Product Change Notification

Date Issued :	February 19, 2024	PCN Number :	514849
Reason for Change :	Change to Product		
Description of Change :	This notification is to inform you about changes that are being made to the part(s) as identified in the list. This change will not affect the Fit, Form, Function. Minor changes on the appearance shall be done.		
Reason for Short Notice :	Special Request		
Assessment of Change :	First Article Inspection		
Planned Implementation Date :	May 31, 2024		
Customer Sample Availability Date:	January 31, 2024		
Last date to request Samples by Customer :	February 29, 2024

Overview

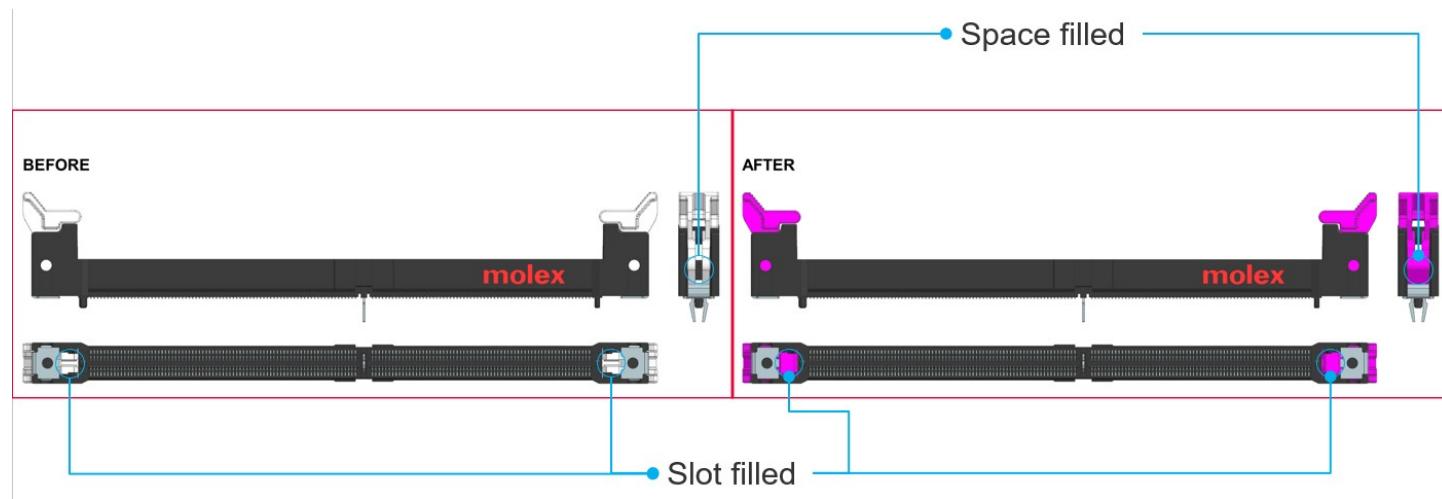
- Latch structure of DDR4 miniDIMM Vertical connector has been strengthened to reduce the risk of breakage during actuation
- Product Impact
 - No impact to fit or function. Form appearance is slightly modified as shown in illustration
- Part Number Impact
 - See attached impacted parts list
- Qualification Reports and samples available upon request after the date shown above
